PLAN COMMISSION MEETING AGENDA

TUESDAY, February 25, 2014
AT 6:00 P.M.

PROJECT: Sign and Light Plan Review – Drexel Town Square

PROJECT: Site Plan Review – Four Points by Sheraton

Sheet Title
LANDSCAPE PLAN

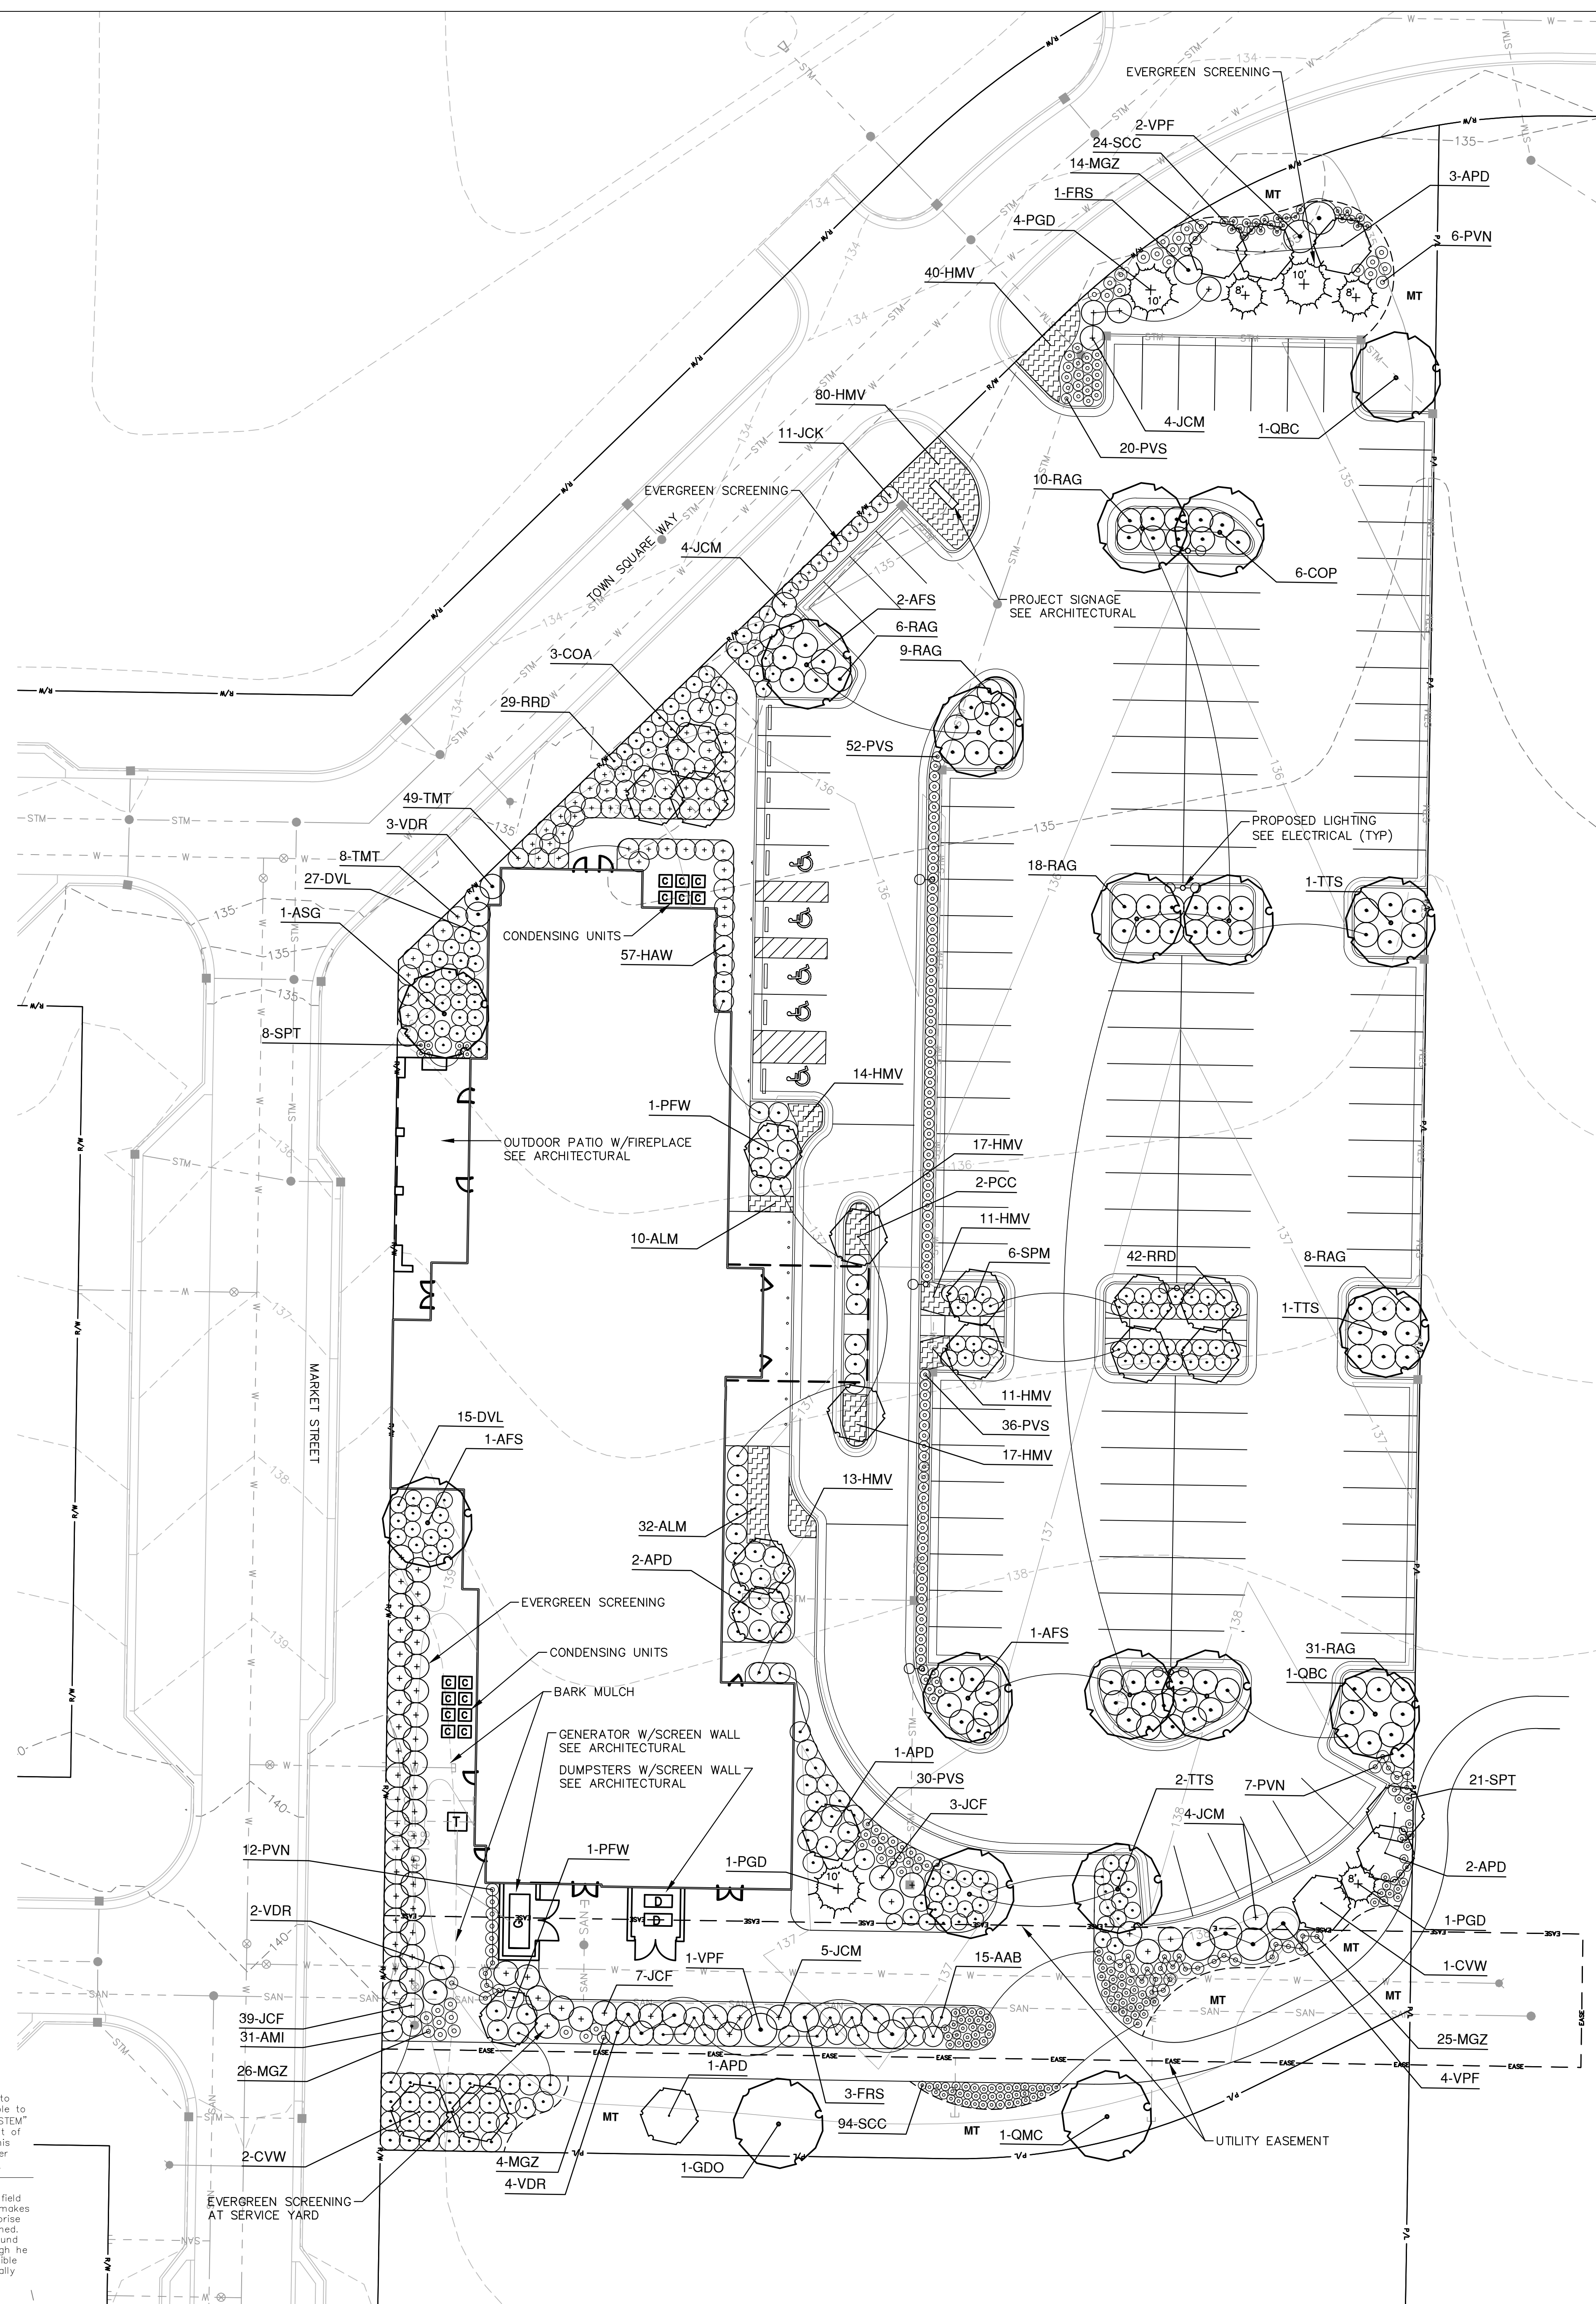
The plans as submitted do not include the LZ on the east between the hotel property and the Meijer property. This will need to be revised to allow for snow storage on the hotel lot as well as to meet the LZ requirement.

Comments on the submitted landscaping plans have been received from the City Forester with regard to species selection and some siting requirements (no vegetation blocking hydrants, etc.). As mentioned

previously, Staff recommends strengthening the landscaping along lot edges, and removing the concrete connection to the public pedestrian walkway on the south. Staff also recommends incorporating permeable pavers wherever possible. The Plan Commission may approve the landscaping plans or delegate final approval to the Director of Community Development and City Forester.

5. That detailed plans for signage are reviewed approved by the Plan Commission.
6. That updated detailed landscaping plans are prepared to reflect changes to the parking lot landscaping.
